UNITED STATES PATENT AND TRADEMARK OFFICE

APPLICATION NO.	FILING DATE	FIRST NAMED INVENTOR	ATTORNEY DOCKET NO.	CONFIRMATION NO.
10/574,035	05/02/2007	Anders Lenning	12400-069	8028
757 7590 10/13/2009 BRINKS HOFER GILSON & LIONE P.O. BOX 10395 CHICAGO, IL 60610				
EXAMINER				
WASI, SHAFQAT				
ART UNIT		PAPER NUMBER		
3654				
MAIL DATE		DELIVERY MODE		
10/13/2009		PAPER

Office Action Summary**Application No.**

DETAILED ACTION

(US Pat. 6,616,081)

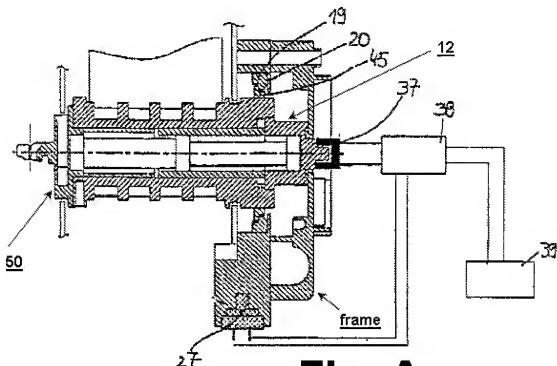
As per claims 4, wherein the two components of the retractor (10) are formed by a spindle within the retractor having a first part of the spindle (see Fig. A below, 50 and a frame) being adapted to be locked from rotating by the locking device (17), a second part of the spindle (12) having the seat belt (9) wound around it, the second part of the spindle (12) movable relative to the first part (see Fig. A below, 50 and a frame) causing the relative movement when the initial belt force in excess of the predetermined force is

As per claims 5, wherein the second part of the spindle (12) is connected to the first part of the spindle (see Fig. A above, 50 and a frame) by means of an energy absorbing torsion bar (13), the energy absorbing torsion bar (13) having two sections (14 and 15 respectively), a first section (14) being operative to provide the first relatively high energy absorbing level and a second section (15) being operative to provide the

As per claims 18, wherein wires are provided to supply the electric signal (see Fig. 8), a part of at least a position of the wire extending from the first part of the spindle (see Fig. A above, 50 and a frame) to the second part of the spindle (12), the part of the wire being configured to be broken upon the relative movement of the second part of the spindle relative to the first part (col. 5, lines 51-67 disclose a control mechanism providing a signal for actuation of the pyrotechnic unit (27). Furthermore, it is noted that any wire is inherently configured to be broken, with or without relative movement).

As per claims 19, wherein the inhibiting element (18) is provided with a deformable portion (13) which is configured to be deformed in response to the relative movement of the second part of the spindle (12) to a first part of the spindle (see Fig. A above, 50 and a frame), the deformable part (13) being positioned to co-operate with a correspondingly configured part of the second part of the spindle (12), to engage the
